# Appendix 9

# Reedy Creek Feasibility Study

**Reedy Creek Stream Restoration and  
Watershed Enhancement Project  
November 22, 2011 – 10:00 a.m.  
On-Site @ Reedy Creek Nature Preserve and Park**

Coordination Meeting For:  
Reedy Creek Stream Restoration  
February 3, 2012, 9:00 am  
Meeting Minutes

**Figure 1**  
Studied Streams

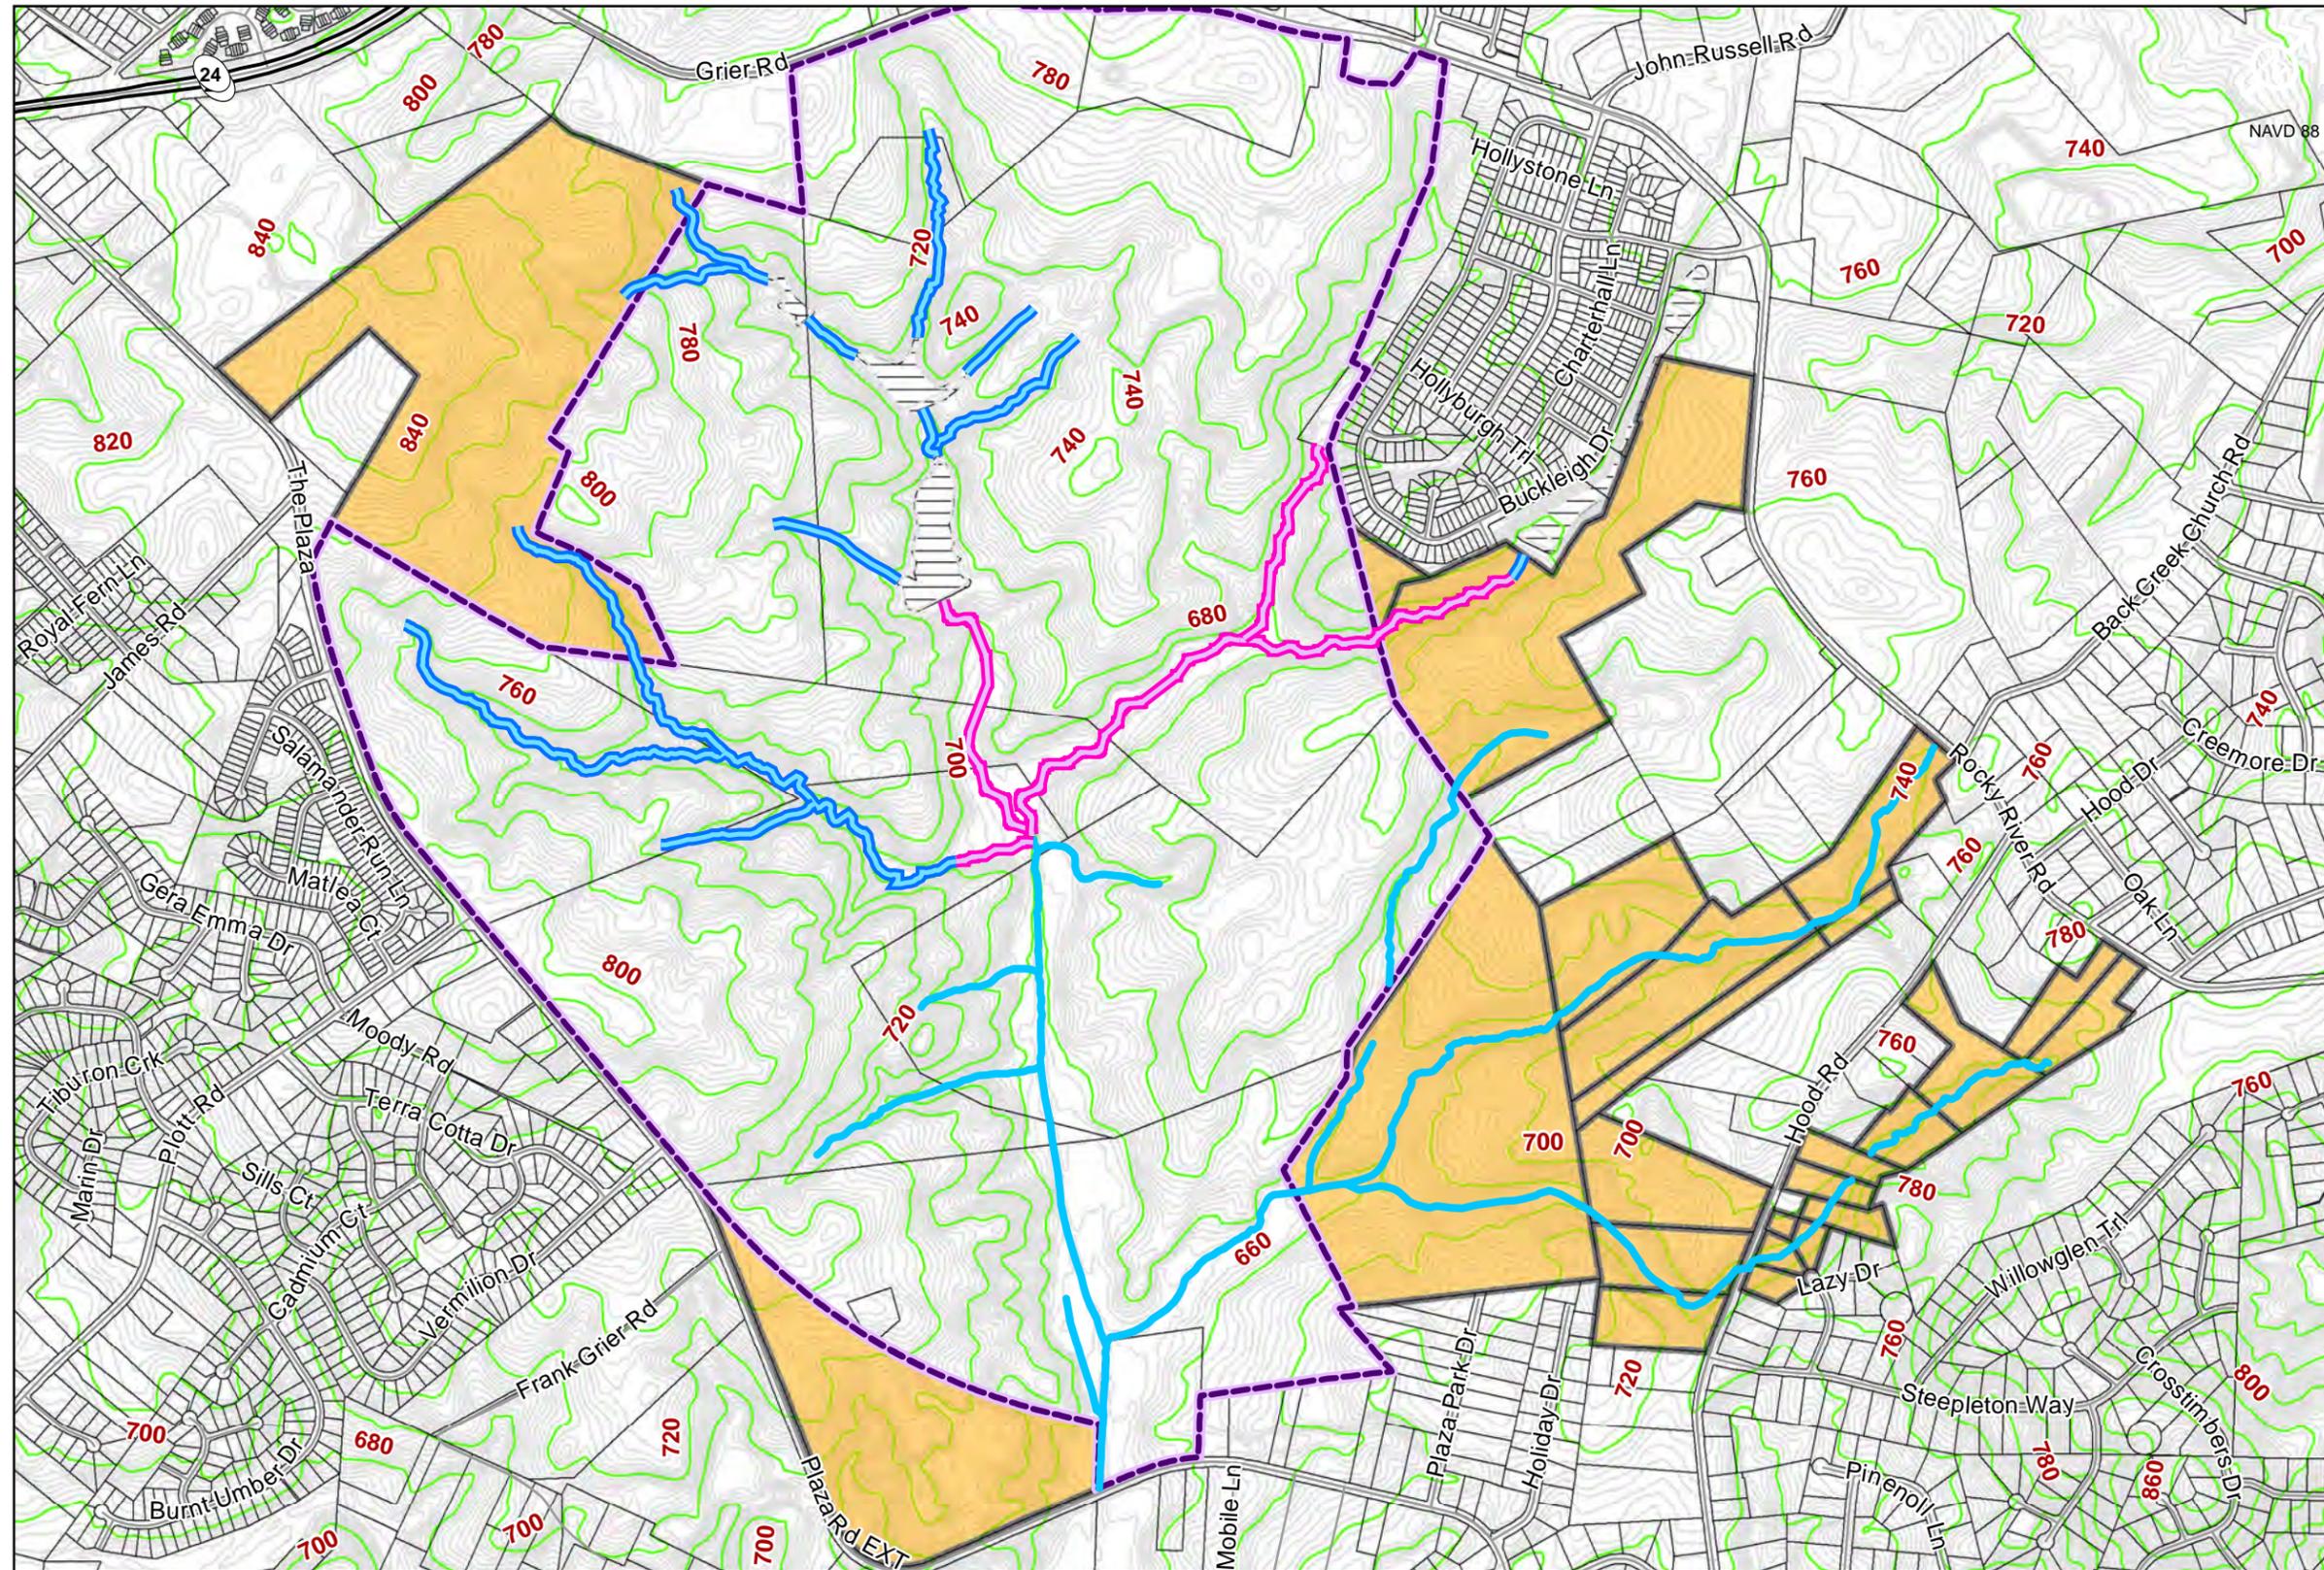
The site contains five stream reaches that have potential for restoration – See attached figure. During the meeting the field team walked to upper reach 5 (proposed as a reference) to gain visual perspective on the reference stable state stream system. The group then walked to lower Reach 2 and Reach 1 both proposed for restoration. The group then walked up to the outlet of Dragonfly Pond which is the start of the proposed restoration area on Reach 2. The team then drove around to the Buckleigh neighborhood and walked to Reach 3 in the Park/Nature Preserve. Reach 4 and lower Reach 5 were not field reviewed. KHA stated that Reach 4 is in a very similar impaired condition to Reach 3 and the lower ~500 feet of Reach 5 is in a similar impaired condition as lower Reach 1 and 2.

Overall USACE and NC DWQ agreed the site had mitigation potential based on this cursory field review and that the City could proceed forward with a Site Specific Mitigation Plan (SSMP). The following comments were made about each reach.

Reach 5

- The group agreed that the upper portions of Reach 5 was a stable reach and provided a good reference.
  - o KHA also noted that the upper sections of Reach 2 above the ponds are also stable and could also be used as reference.

Reach 1

- Agencies agreed that this reach is visually the most impaired they saw in the park.
- NC DWQ expressed concern that if priority one restoration (i.e. raising the stream bed 6-8 feet) is used, would ground water respond .
  - o CMSWS pointed out that similar projects in the County (i.e. Edwards Branch Phase III) where priority one was used, the ground water has responded favorably and stream base flow returned almost immediately to the newly constructed channel.
  - o KHA pointed out that it will be important to plug the old channel to prevent it from being a drain which could pull down ground water.

- KHA also pointed out that some initial soil borings were done and those would be reviewed in more detail as it relates to existing and proposed groundwater stream base flow hydrology.
- All parties agreed that additional investigation and analysis will need to be performed and documented in the SSMP.

### Reach 2

- All parties agreed that this stream segment is entrenched (i.e. has abandoned its historic floodplain) with bank heights over six feet.
- NC DWQ noted some areas of stable banks among the vertical eroding banks.
  - KHA noted that although there are some short segments where the bank has sloughed in and have become temporarily stable the overall reach is unstable and still actively eroding.
  - City noted that the stream lacked habitat/bed form diversity (i.e. no riffle and pools).
- All agreed the outlet of Dragonfly Pond provided a good starting point and the elevated invert elevation of the outlet pipes allowed for an opportunity to raise the stream bed up.
- The group also noted some relic gabion baskets and/or Reno mattress downstream of the pond outlet. The group agreed that this area could be improved.

### Reach 3

- The group agreed this reach is incised/entrenched with vertical eroding banks.
- USACE and NC DWQ asked about storm water inputs from the neighborhood into reach 3 and 4.
  - The City stated that a portion of the neighborhood drains to a wet pond on Reach 4.
  - KHA stated that a priority one restoration would allow the existing stream segments around stormwater inputs to be converted into pocket BMPs to provide treatment prior to the stormwater reaching the relocated priority one restored stream.
